Urban Design Consultation

Proposal: Discharge of condition 3 (materials) of 24/00515/HDC	**Location: Priory Centre Priory Lane St Neots**
Case Officer: Lucy Pateman	**Application: 24/80406/COND**

Comments in blue text are in response to amended plans received 14/02/2025, which have been updated to better reflect the detailing submitted under condition 4 Architectural Details (25/80035/COND).

North Extension: 'Michelmersh Freshfield Lane Selected Light' facing brick and 'red light' mortar, Copper cladding, and RAL 3012 Beige Red sample of window colour:

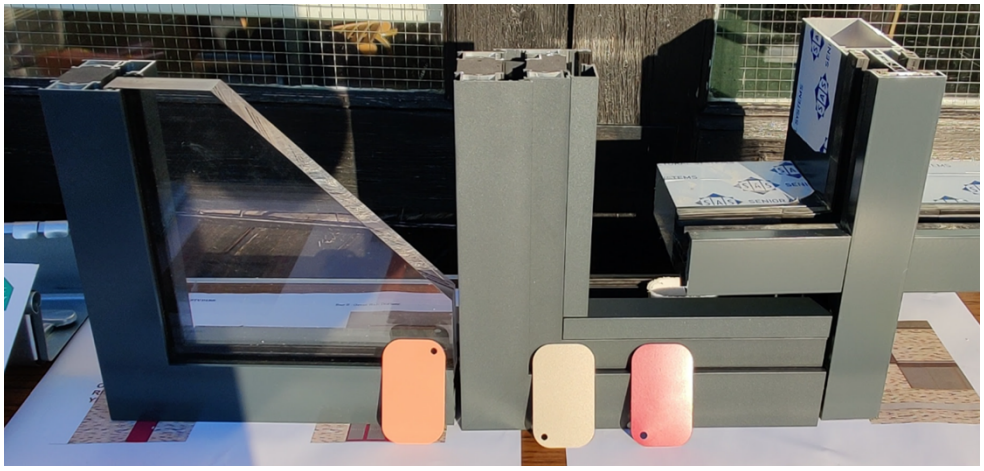
Photos of samples:
Samples of the materials, finishes and colours were reviewed on site on the 24/10/2024:
